## UNITED STATES PATENT AND TRADEMARK OFFICE

# Office Action Summary

10/700,390

## **DETAILED ACTION**

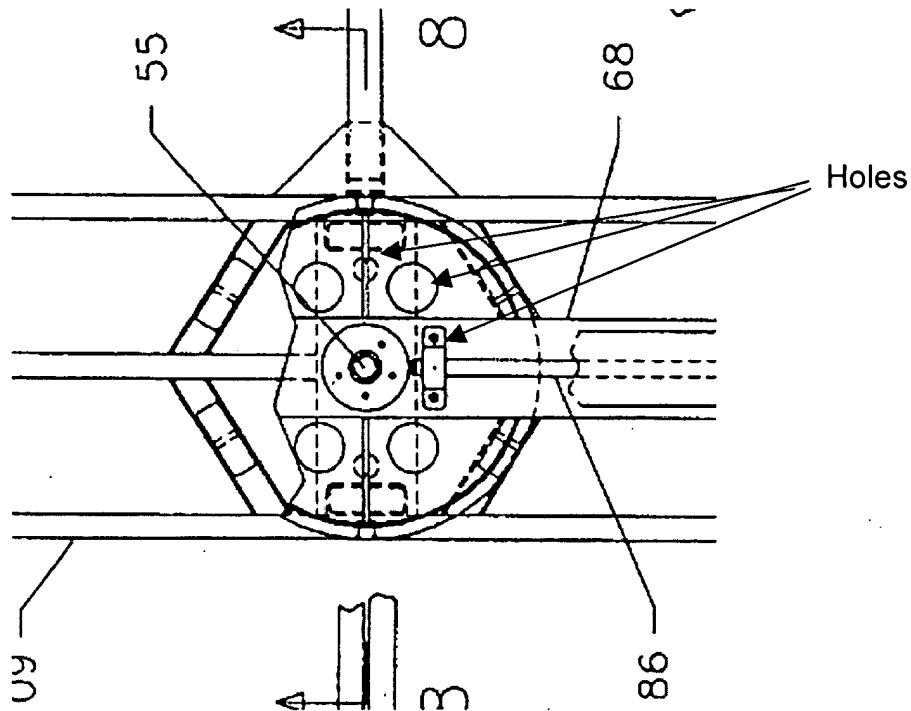
With respect to claim 2, referring to FIGS. 6-8 Andol '082 discloses an arc shaped bearing plate 64,82.

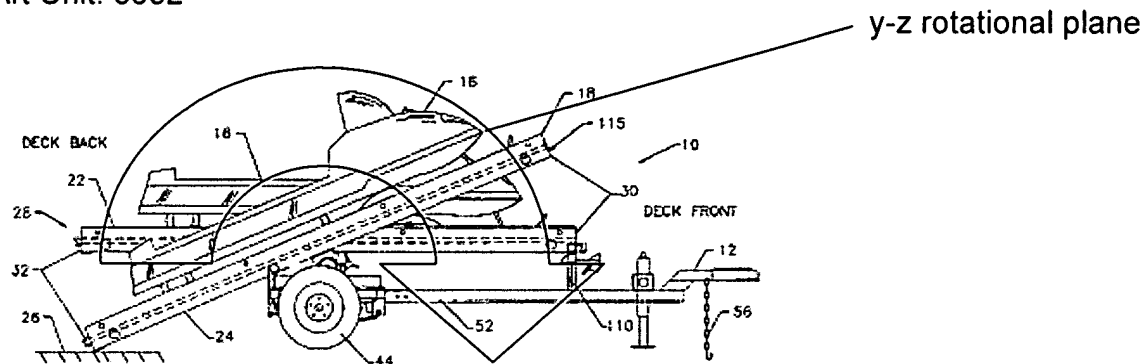
With respect to claim 3, referring to FIG. 6 Andol '082 discloses a bearing plate 64,82 having holes as defined by those apertures as shown below.

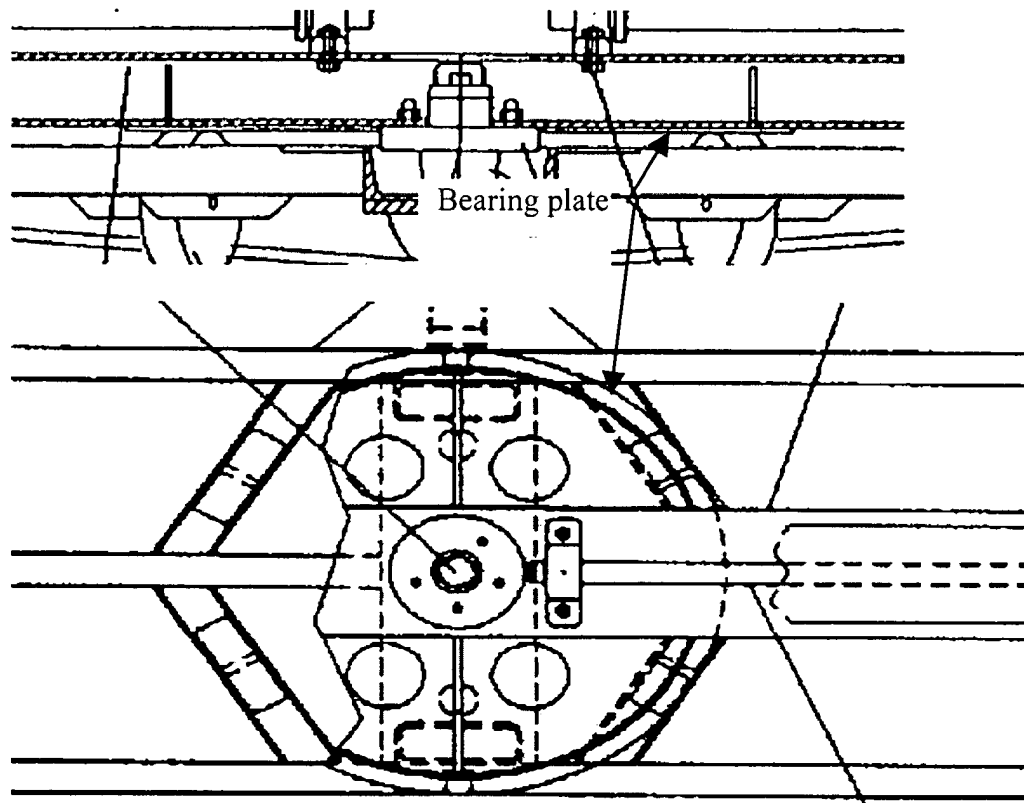
With respect to claims 2 & 3, applicant argues Andol '082 bearing plate holes "do not serve any purpose or function in the operation of the invention" is without merit. For better definition, Andol's FIGS. 6 & 7 are reproduced below. A bearing plate and holes allow for fastening of a bearing plate to and allow for rotation of a turntable 66, 72. It is

noted that applicant provides no structure linking a bearing plate holes to positioning structure, i.e. spring-loaded pin, horizontal plate hole, etc. in applicants claim 5.
